Request for Information

Project: RFPD Fire Station #3
RFI Number: 2
Date: 7/10/2009

Subject: Grading and Drainage Plan Review, Rifle Fire Station #3, Lot 18, Grand River Plaza, Last Chance Drive, Rifle, Colorado

FD-1.0

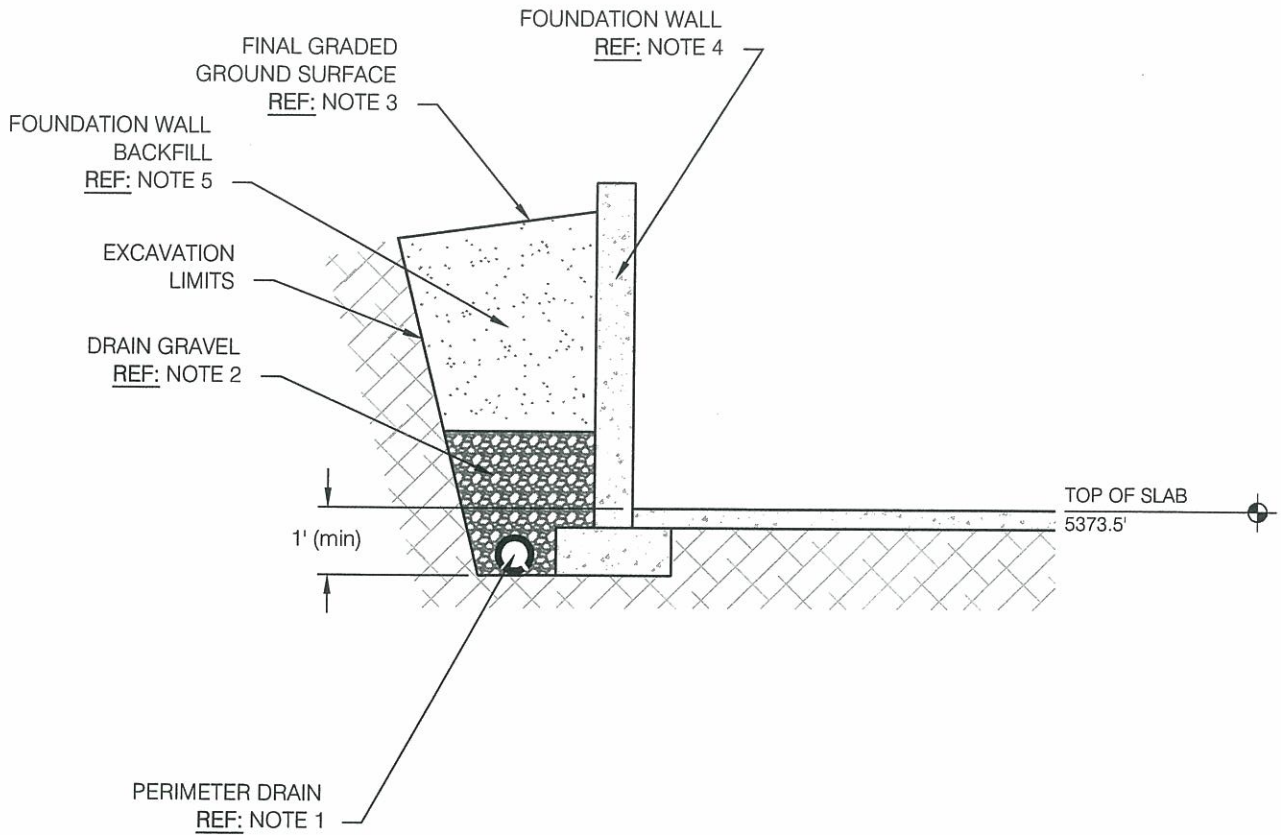
We are lacking a design for the foundation drain. The plans refer to the soils report for details however there is no construction specific design details in the soils report. Also how will the foundation drain tie into detail 3 on page R2.

Refer to the attached document from HP Geotech on the design and location of the foundation drain.
Extend the geotextile cover (noted on sheet R2) beyond the footing so that it covers the drain pipe at the footing

Underdrain System (Item Nos. 7 & 11): Recommendations for underdrains at the site are provided in our previous report (Hepworth-Pawlak Geotechnical, 2009). Based on our review of the proposed grading plan, a perimeter foundation drain should be provided behind the south and west foundation walls where the interior floor slab elevation is lower than the exterior ground surface. A schematic drain alignment is shown on Figure FD-1.0 and typical drain detail is shown on Figure FD-2.0. The foundation drain should consist of 4-inch diameter, rigid PVC pipe surrounded by free-draining granular material. The drain should be placed at least 1 foot below lowest adjacent finish grade and sloped at a minimum ½% to a suitable gravity outlet. Other recommendations presented in our
